APPLICATION NO: 21/2021/1049/ PF

PROPOSAL: Erection of a replacement dwelling and associated works

LOCATION: Heather Bank, Llanferres, Mold CH7 5SF

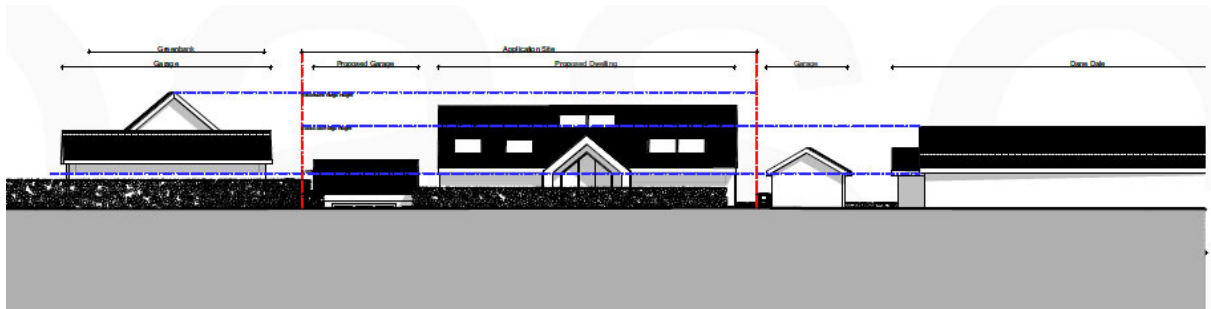
A number of objections were raised regarding visual amenity by neighbours directly to the north and south of the site, but also properties along Bryn Artro Avenue. In summary, these related to the proposals being an overdevelopment of the site – going from a single storey dwelling to what was originally a two storey dwelling; the massing, height and scale of the proposed dwelling; the proposals being out of character with the adjacent dwellings and having been moved back; that people felt it should keep the same build line and be a single storey or one and a half storey dwelling; that the materials should be more in keeping with the surrounding properties; that it was not in keeping with the Area of Outstanding; queries over the ability to achieve the land levels and need to retain the hedges as existing.

The Area of Outstanding Natural Beauty Joint Committee also raised initial objections to the proposed scale and mass of original proposal. It was considered the initial design was out of character with the neighbouring properties and did not respond to the site context or form and scale of neighbouring dwellings. They also considered that the proportions of the new dwelling would remain highly conspicuous within the landscape and would be visually prominent in comparison with surrounding development. Whilst the design and use of materials were considered acceptable there are concerns regarding the overall mass and scale of the dwelling which would

detract from the character and appearance of the AONB. The design has been subsequently amended as shown below:

The amended plans that are now being considered significantly reduce the scale and mass of the proposed dwelling (see red dotted line of original proposal). The rear elevation has been moved in significantly. The plans detail the proposed ridge to be below that of the one and a half storey to the north and only slightly above the bungalow to the south. The proposals omitted the double gables to the rear and the proposed balcony has been reduced to be sunk into the roof which would have the effect of screening views to either side also. The porch to the front is also now a pitched roof feature which is considered much more in keeping. The street scene elevation below shows the relationship between the roof heights (the proposed dwelling is shown as the central building):

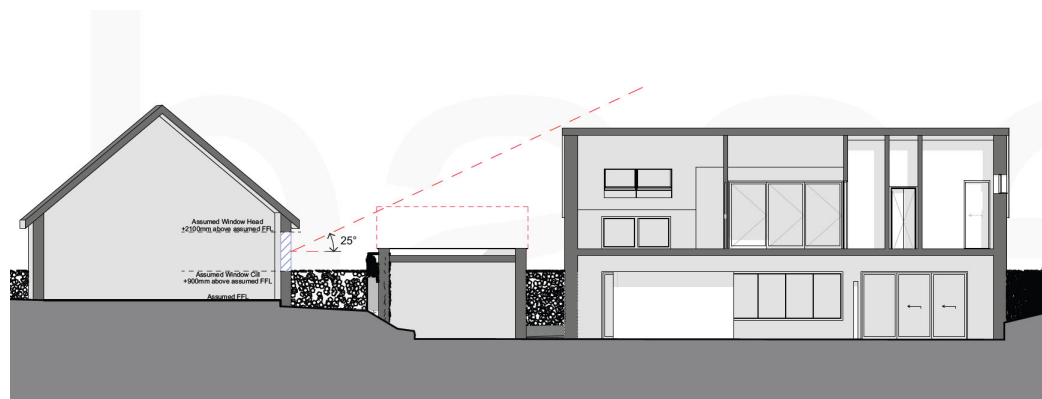
Representations have been made by local residents regarding concerns about impacts upon residential amenity. As discussed in the previous section, the original plans included a balcony that was the full width of the dwelling. This has been removed along with the two protruding gables to the rear and replaced with a balcony that is sunken into the roof. Any views from the balcony are therefore obstructed by the roof slope. This directs any views to be enjoyed from the balcony predominantly towards the open fields. The nearest property on Bryn Artro Avenue would be 40m from the proposed dwelling.

It is therefore considered that the proposed balcony will not have an impact of overlooking or loss of privacy – the main views will be over the agricultural field to the rear.
